Access Compliance Report

Public Rights-of-Way

Intersection ID: N/A	Main Street: PROVIDENCE_COUNTRY_CLUB_DR	Cross Street: MCGILL_HEIGHTS_RD	Location: NW
ADA ID: D791D941A17A	Ramp Type: Perp	Initial Pass/Fail: Fail	Overall Compliance: No
Codes/Mitigation Info/Possible Solution		Field Measurements/Component Compliance	
Severity Score: 12.5

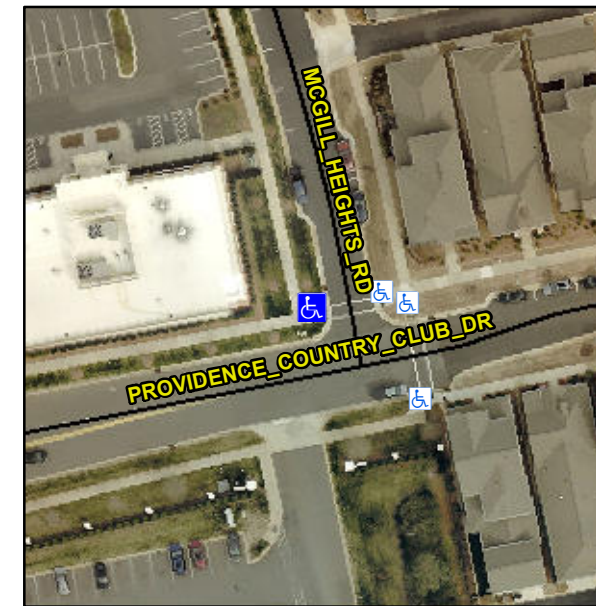
Not Found, R304.2.2

Compliance	Description	Data	Compliance	Description	Data
N/A	Ramp Length (in)	84.0	No	Ramp Slope (%)	9.8
Yes	Ramp Width (in)	70.0	Yes	Ramp XSlope (%)	1.3
N/A	Flare Type LT	N/A	N/A	Flare Type RT	N/A
N/A	Flare Slope LT (%)	N/A	N/A	Flare Slope RT (%)	N/A
N/A	Flare Traversable LT?	N/A	N/A	Flare Traversable RT?	N/A
N/A	Landing Length (in)	N/A	N/A	DWS Provided?	N/A
N/A	Landing Width (in)	N/A	N/A	DWS Contrast?	N/A
N/A	Landing Slope (%)	N/A	N/A	DWS Length (in)	N/A
N/A	Landing X Slope (%)	N/A	N/A	DWS Full Width?	N/A
N/A	Landing Curb? (Y/N)	N/A	N/A	DWS Offset (in)	N/A
N/A	Shared Landing?	N/A			
N/A	Gutter Ponding?	N/A	N/A	Gutter Slope (%)	N/A
N/A	Gutter Lip Ht (in)	2.5	N/A	Gutter X Slope (%)	N/A
N/A	Painted X Walk1?	No	N/A	Painted X Walk2?	N/A
	X Walk 1 Direction	To E		X Walk 2 Direction	N/A
N/A	X Walk 1 Width (in)	N/A	N/A	X Walk 2 Width (in)	N/A
	X Walk 1 Slope (%)	0.1		X Walk 2 Slope (%)	N/A
	X Walk 1 X Slope (%)	2.4		X Walk 2 X Slope (%)	N/A

Remove & Replace Entire Ramp.
